A24
LONDON ROAD
WEST SIDE

Cycle signage issues at
Croft Road bus stop

Northbound opposite Station Approach

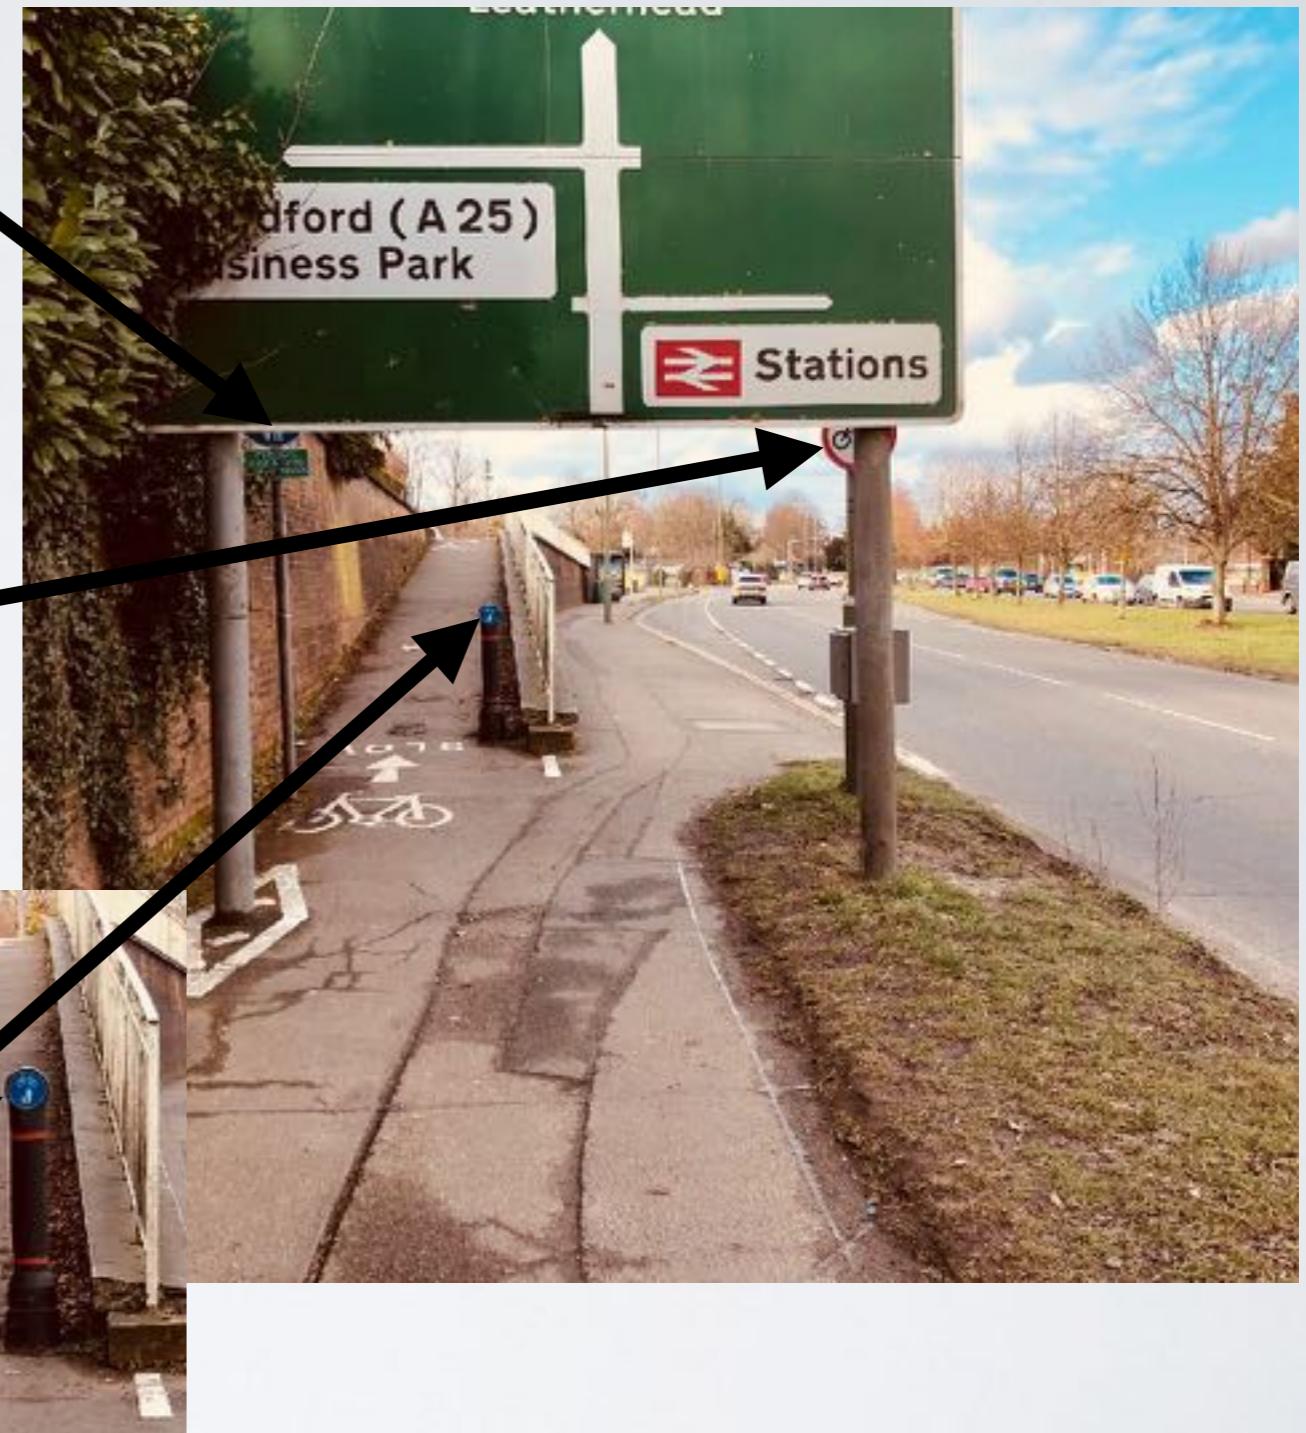
Obscured “Dual use” Sign?

Obscured “No Cycling” Sign?
Its size and position implies
that cycling on the highway
(A24 Northbound) is not
permitted.

The “Dual use” Sign on the
post is cute, rather small and
conflicts with the painted cycle
route sign.

The painted “SLOW” instruction might be useful, twenty or so yards further up the slope.

Segregate cyclists and pedestrians earlier

The “No Cycling” sign on the right on the pillar supporting the sign is ambiguous.

The “Shared use” sign on the left on the pillar supporting the sign is ambiguous, redundant and conflicts with the painted path sign.

A “Pedestrian” roundel painted on the footway would be better.

A “Shared Use” roundel painted on the footway would be better.

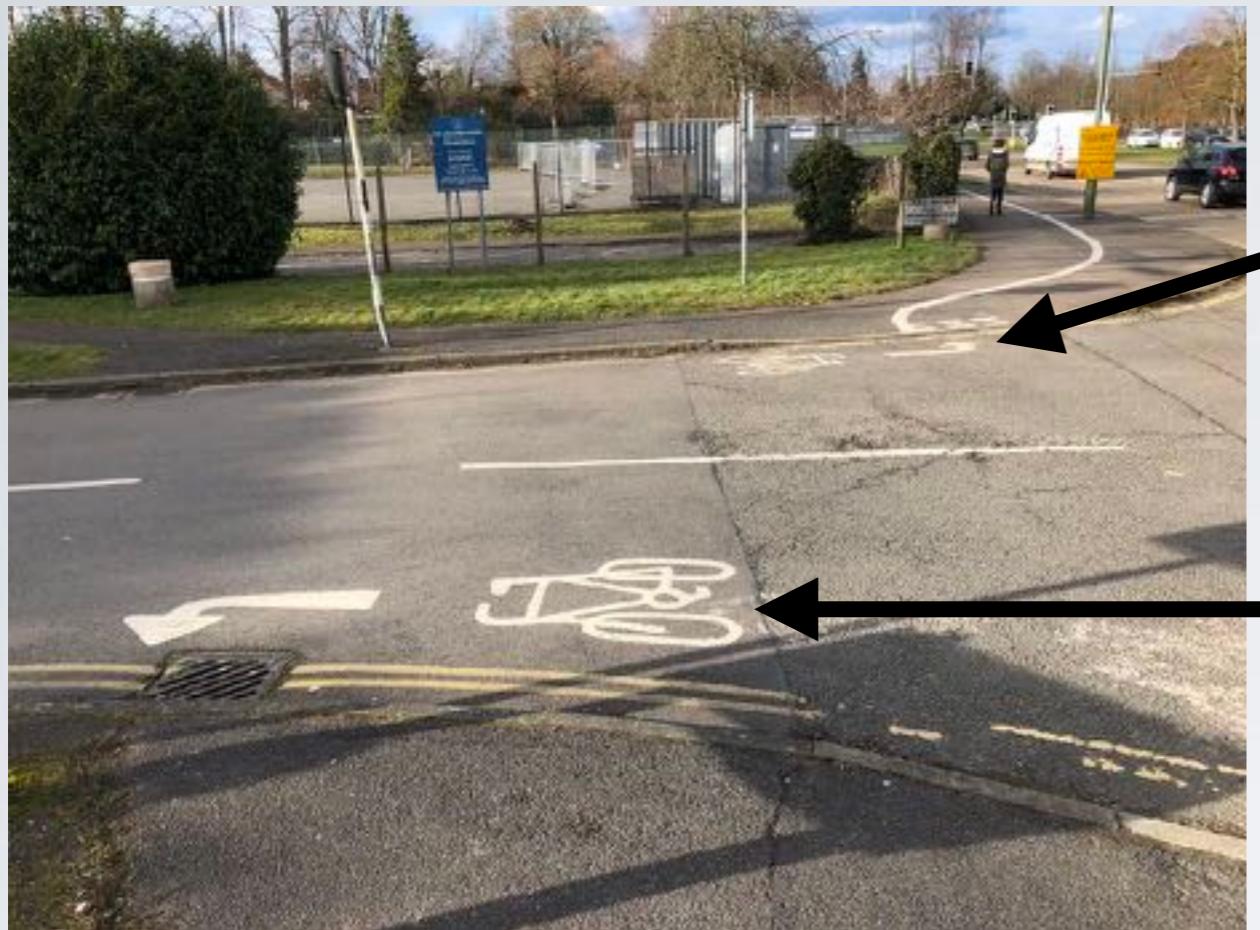
Continuing Northbound, there are “No Cycling“ signs past the Bus stop where the pavement is wide enough for dual use and there is no danger of pedestrian/cyclist conflict.

If the signs south of the Bus stop are effective there will be no cyclists at this point.

This little bollard is a nice design. The sign is a good height for cyclist awareness, it is large enough to be visible and its message understood. It points in the wrong direction.

There is an arrow on the road telling you what to do heading Northbound

Heading southbound, the arrow is on the far side (just below the road name sign).

The South side direction arrow seems to imply that the cyclist should mount the pavement.

Better to elongate the arrow to follow the curve of the road.

Heading Southbound from Ashcombe Road

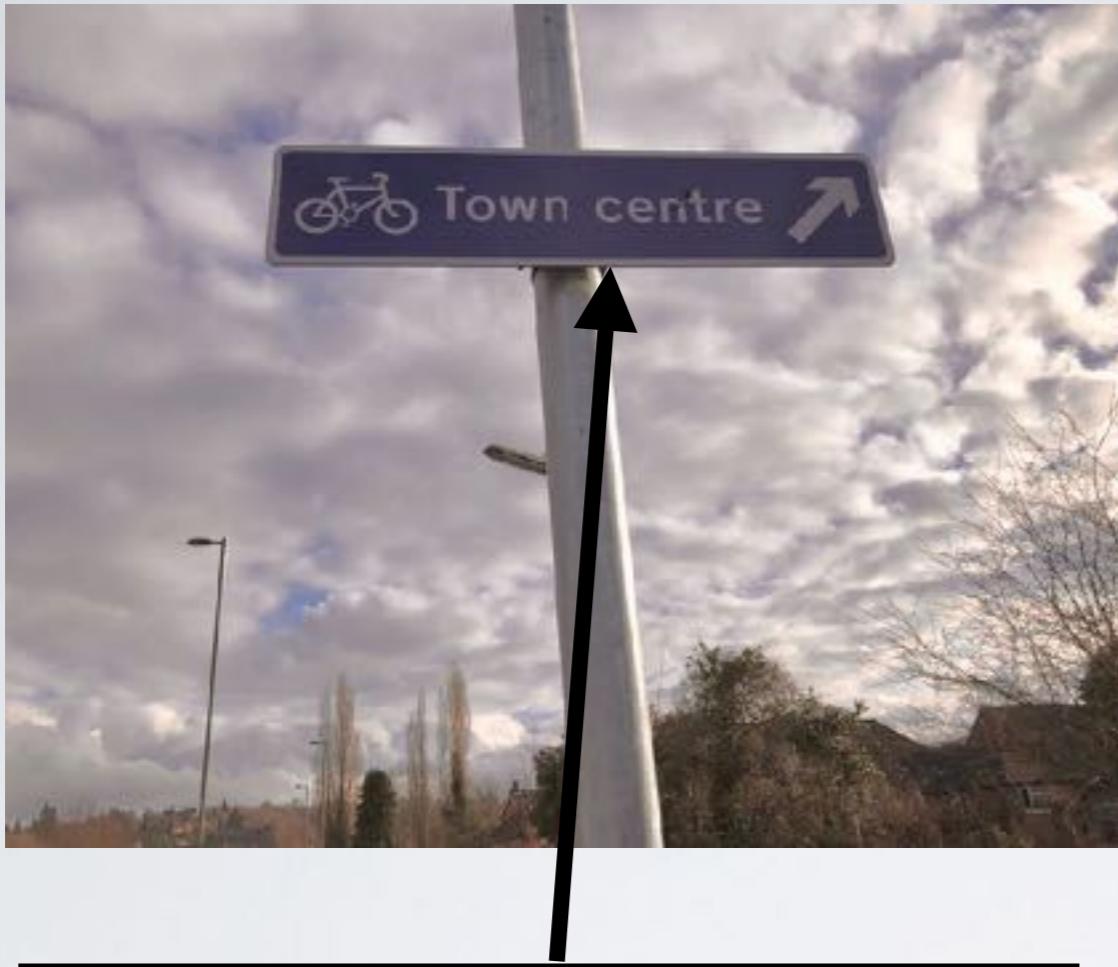
No indication as to who the lanes belong to.

Lamp post in middle of cycle lane despite representations and installation contract.

SCC Highways sign completely blocks Cycle Lane. It should be above 2.1 metres

Sign to Town Centre misleads users into thinking there is a short cut through Croft Avenue. The sign is too high for Cyclists and unclear against the bright southern sky.

Painted signs would make it clear.

Placed here, the “Town Centre” sign is clearly aimed at cyclists, particularly combined with the elongated arrow. You can also get rid of a post.
